Agenda item: Release 2000 issues / AH22
Source: Nokia
Title: Further clarifications on outer loop power control during DPCCH gating

Document for: Discussion & Decision

Figure 1: Transport channel multiplexing structure for uplink

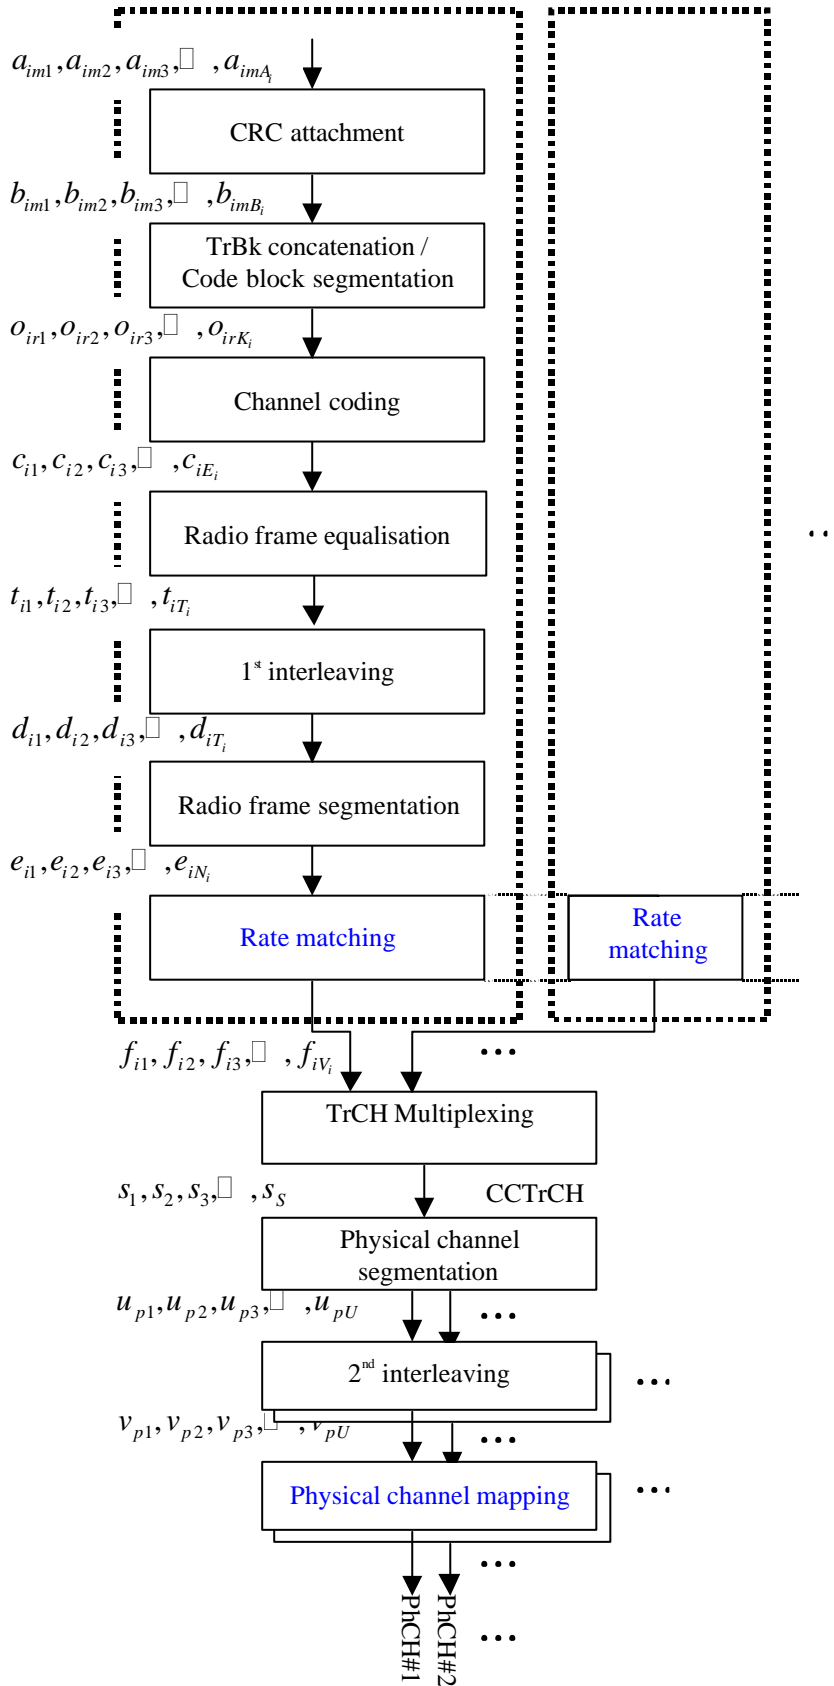
appendix , what parts of the multiplexing diagrams would be affected, it is shown there in blue. The detailed explanation of the required changes for the alternative B are given in the next section.

4.3 Rate matching in uplink

Required changes:

- 1) In embedded mode, the same definition can be used as before. So no changes needed.
- 2) In normal gating mode, $N_{data,j}$ needs to be replaced by $N_{data,j}^{gating}$, where:

$$?? N_{data,j}^{gating} = N_{data,j} / 3 \text{ if gating rate}=1/3$$

$$?? N_{data,j}^{gating} = N_{data,j} / 5 \text{ if gating rate}=1/5$$

Figure 2: Transport channel multiplexing structure for downlink

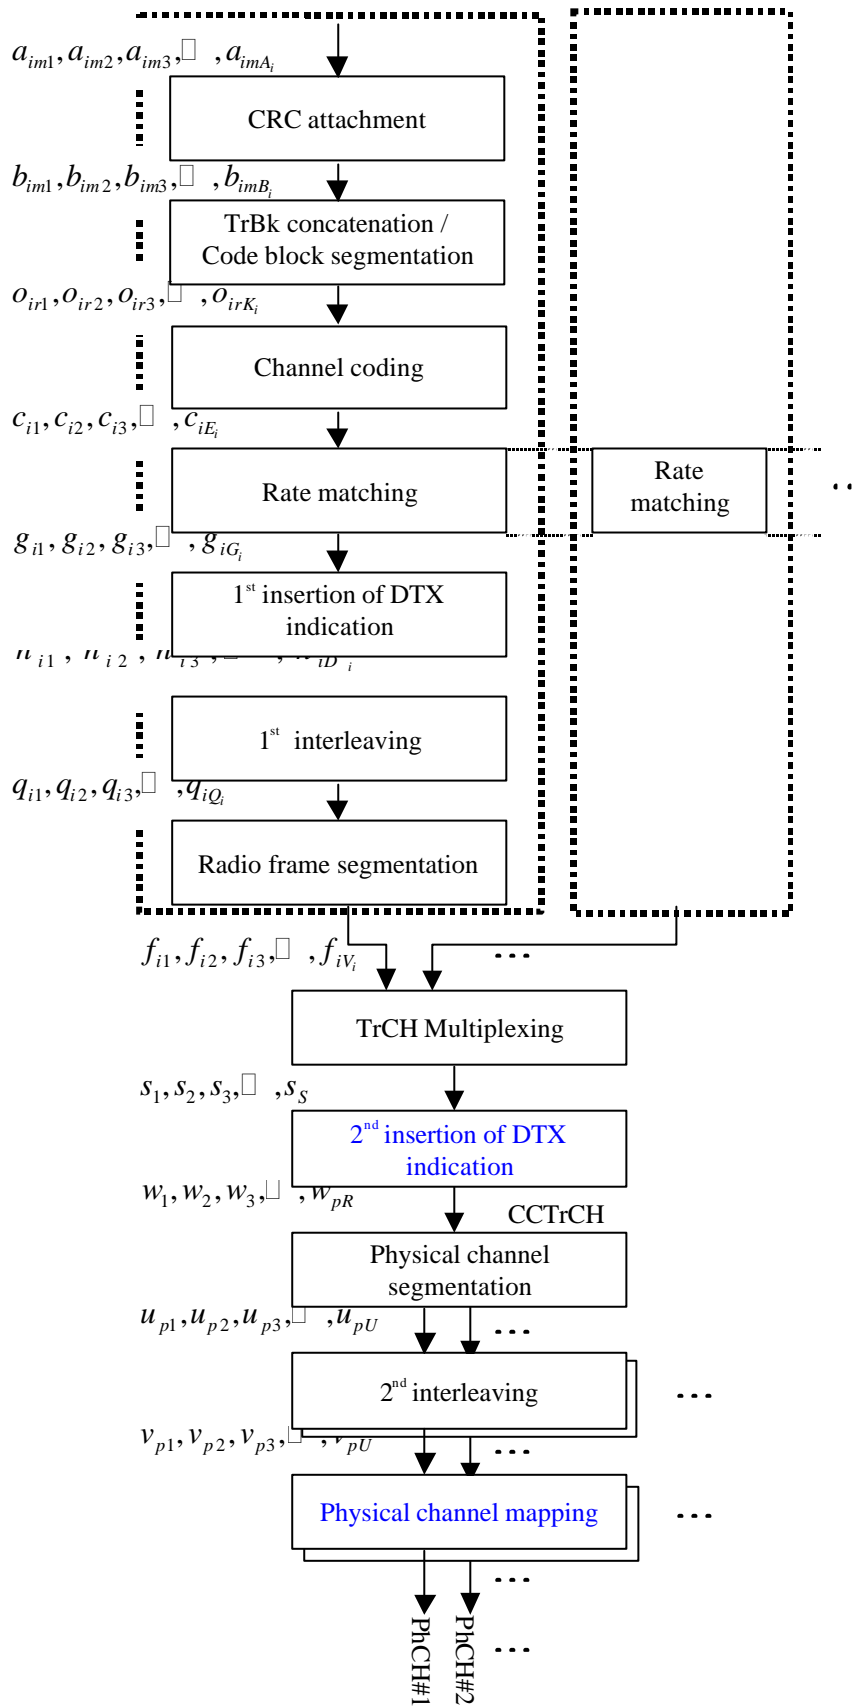
4.2 2nd Insertion of DTX indication bits in downlink

Required changes:

2) During normal gating mode, R needs to be replaced by R_{gating}, where:

?? R_{gating}=R/3 if gating rate=1/3

?? R_{gating}=R/5 if gating rate=1/5
